# Assessment of the Potential for Criticality in Decommissioned Spent Fuel Pools

**Comments on NRC Draft Screening Criteria for Assessing Potential Seismic Vulnerabilities of Spent Fuel Pools at Decommissioning Plants - December 3, 1999 NRC Memorandum**

Subject: Additional Documents Concerning Seismic Screening and Seismic Risk of Spent Fuel Pools For Decommissioning Plants

**Figure 1** PWR High Density Storage Rack Eigenvalue following Compressive/Expansion Events

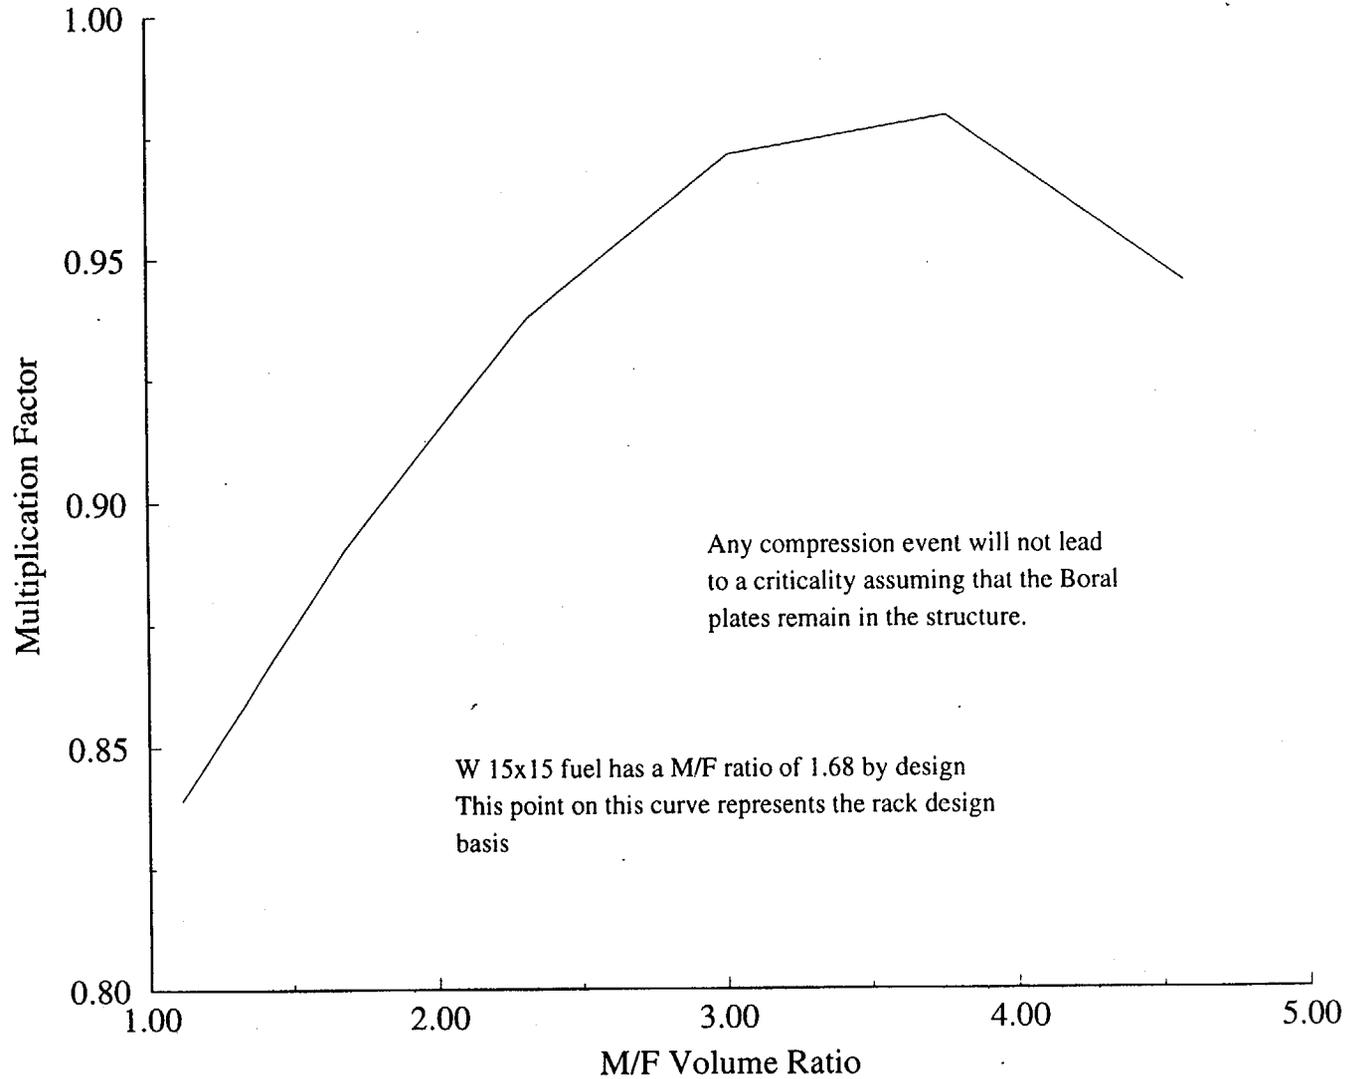
The analyses and this discussion will differentiate between high and low density storage. High density storage is defined as racks that rely on both fixed poison sheets and geometry to control reactivity and low density storage relies solely upon geometry for reactivity control. The results of the analyses for the high density storage racks is summarized in Figure 1. When discussing Figure 1 it should be noted that the analyses supporting Figure 1 were performed without soluble boron and with fuel at the most reactive point allowed for the rack. These assumptions represent a significant conservatism of at least 20 percent delta-k. Figure 1

demonstrates that even with compression to an optimal geometric configuration, criticality is prevented by design (for these scenarios we are not trying to maintain a  $k_{eff}$  less than 0.95). The poison sheeting, boron in this case, is sufficient to keep the configuration subcritical.

**Figure 2** PWR Low Density Storage Rack Eigenvalue following Compressive/Expansion Events

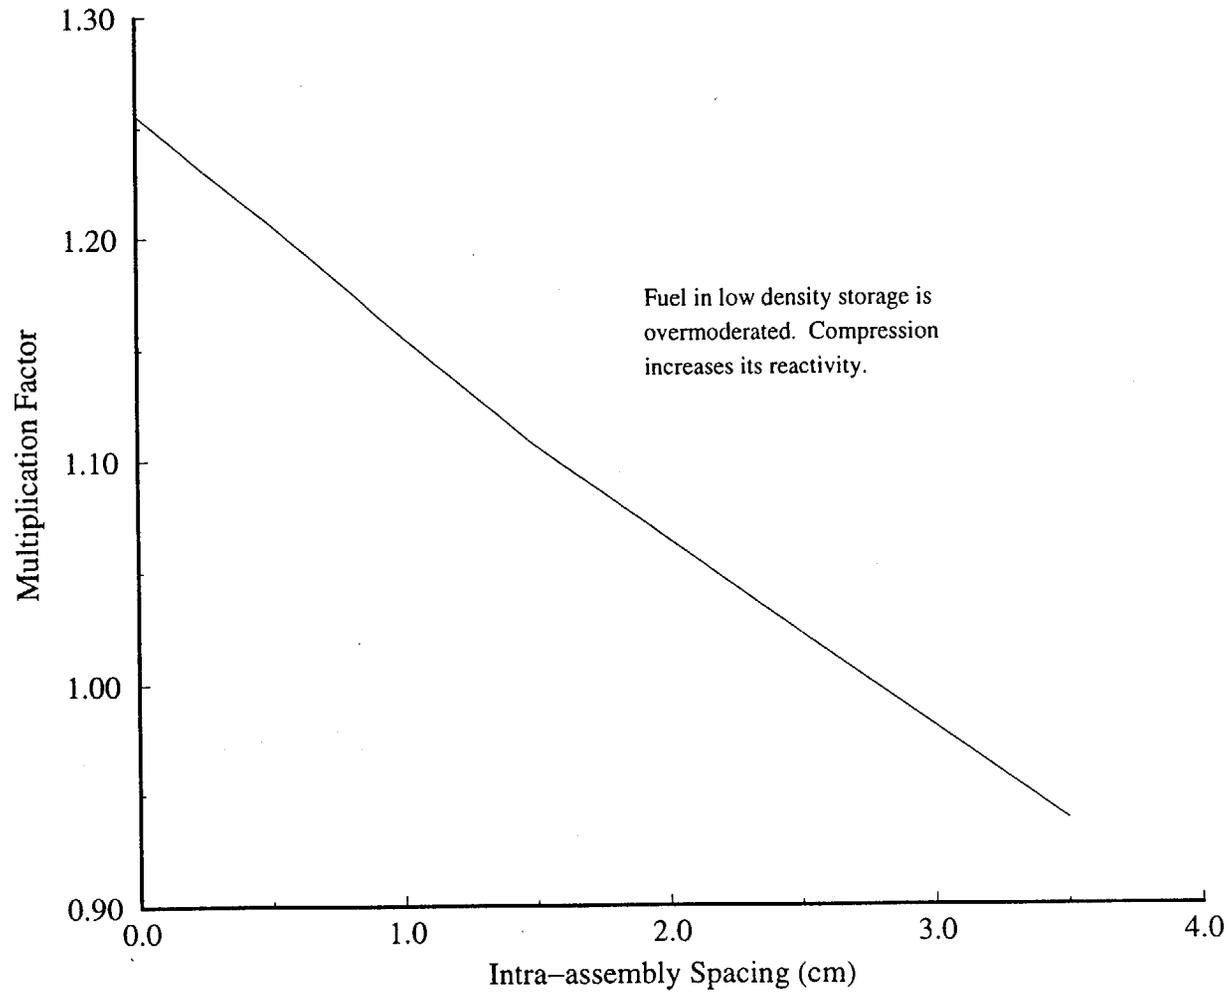
The results for the low density storage rack are given in Figure 2. As can be seen, criticality cannot be entirely ruled out on the basis of geometry alone. Therefore, we examined the conservatism implicit in the methodology and assessed whether there is enough margin to not require any additional measures for criticality control. There are two main sources of conservatism in the analyses; using fuel at the most reactive state allowed for the configuration and not crediting soluble boron. By relaxing the assumption that all of the fuel is at its peak expected reactivity, we have demonstrated by analyzing several sample storage configurations that the rack eigenvalue can be reduced to approximately 0.998 (see Table 1). The storage configurations analyzed included placing a most reactive bundle every second, fourth, sixth and eighth storage cell (see Figure 3). The assemblies used between the most reactive assembly were defined by burning the 5 w/o  $U_{235}$  enriched Westinghouse 15x15 assembly to 55 GWD/MTU which is a typical discharge burnup for an assembly of this type. This study did not examine all possible configurations so this value should be taken as an estimate only. However, the study does suggest that scattering the most reactive fuel throughout the pool would substantially reduce the risk of a criticality accident. It is difficult to entirely relax the assumption of no soluble boron in the pool, but its presence will allow time for recovery actions during an event that breaches the SFP liner and compresses the rack but does not rapidly drain the pool.

**Figure 4** BWR High Density Storage Rack Eigenvalue following Compressive/Expansion Events

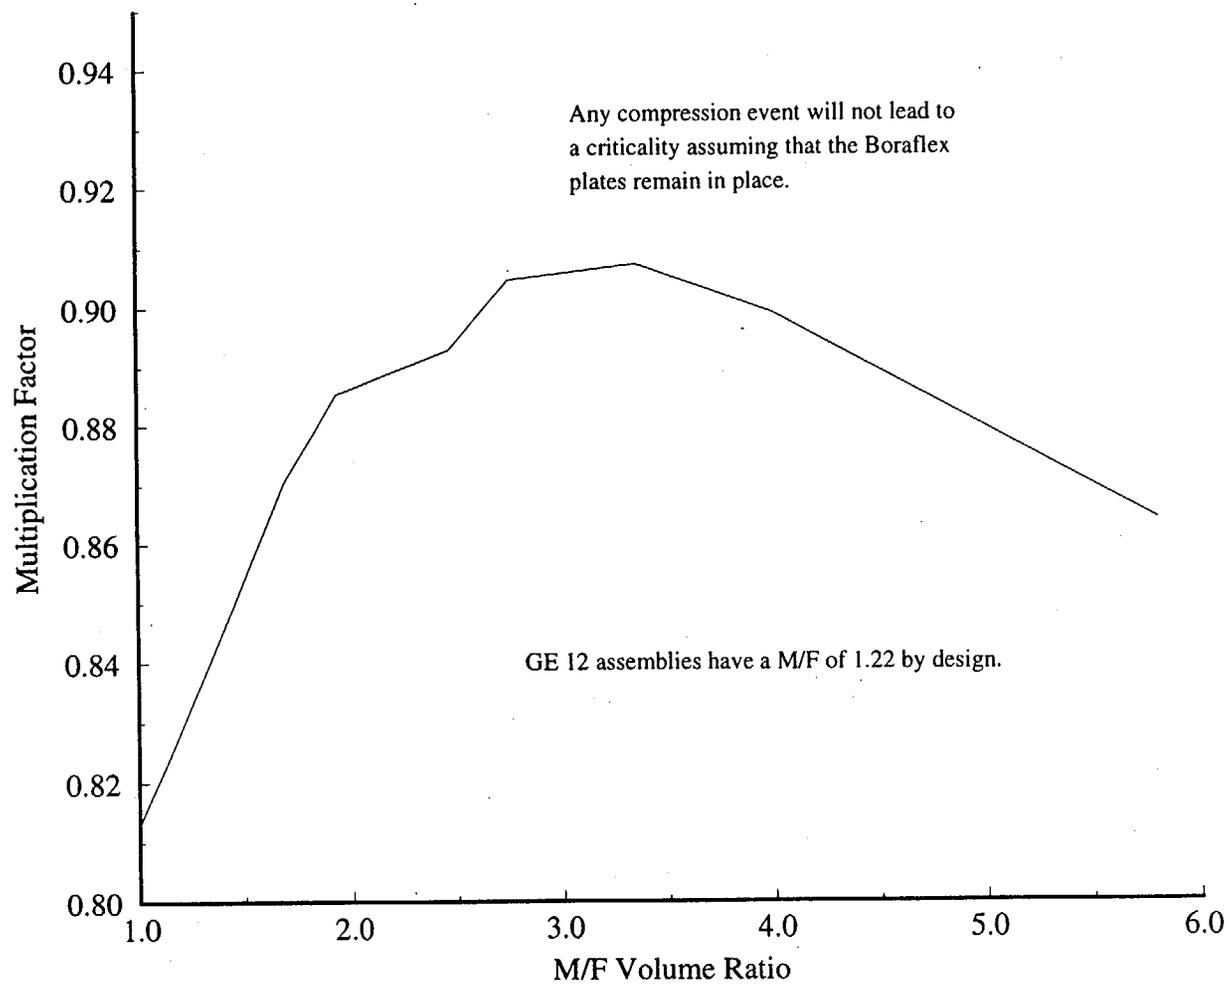
In these analyses, we differentiated between high and low density BWR racks. The conservatism inherent in the analyses must be considered (for BWR racks, the use of the most reactive fuel allowed only) when considering the discussion of these results. The results of the analyses of high density BWR racks are given in Figure 4. As can be seen, criticality is prevented by design for the high density configurations. The poison sheets remain reasonably intact following the postulated compression event. The poison sheeting (in this case Boraflex) is sufficient to maintain subcriticality.

**Figure 5** BWR Low Density Storage Rack Eigenvalue following Compressive/Expansion Events

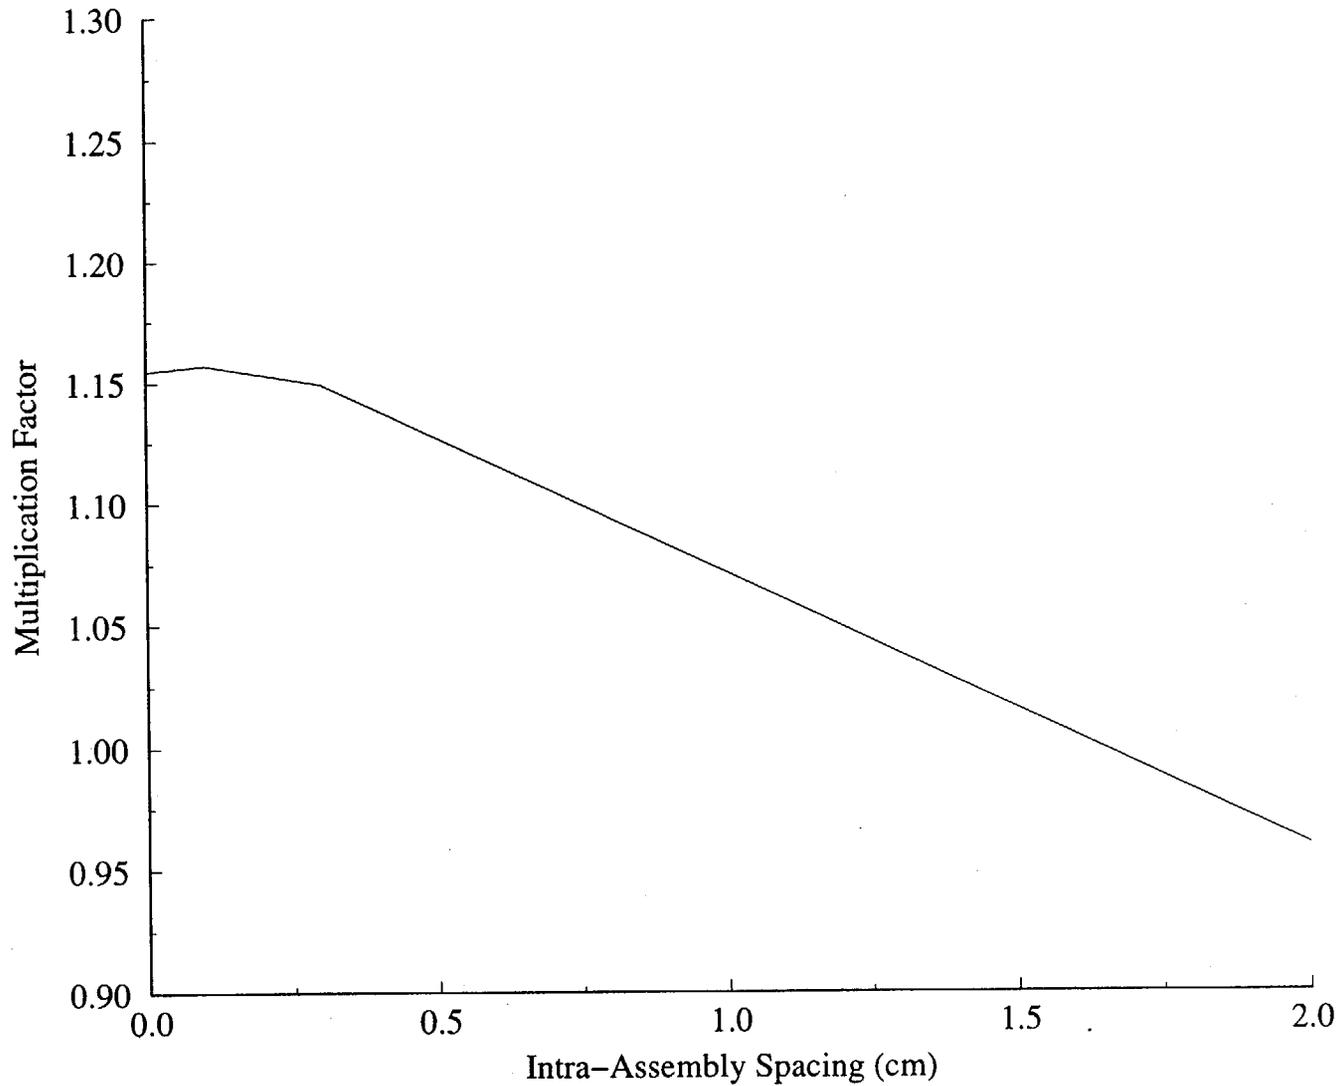
The results of the low density BWR rack analyses are shown in Figure 5. Here, as with the PWR low density racks, criticality cannot be prevented by design. Once again we assessed the impact of eliminating some of the conservatism in the analyses which in the case of BWR storage is only related to the reactivity of the assembly. Analyses were performed placing a most reactive assembly in every second, fourth, sixth and eighth storage cell. The assemblies placed between the most reactive assemblies were defined by burning the 4.12 w/o enriched
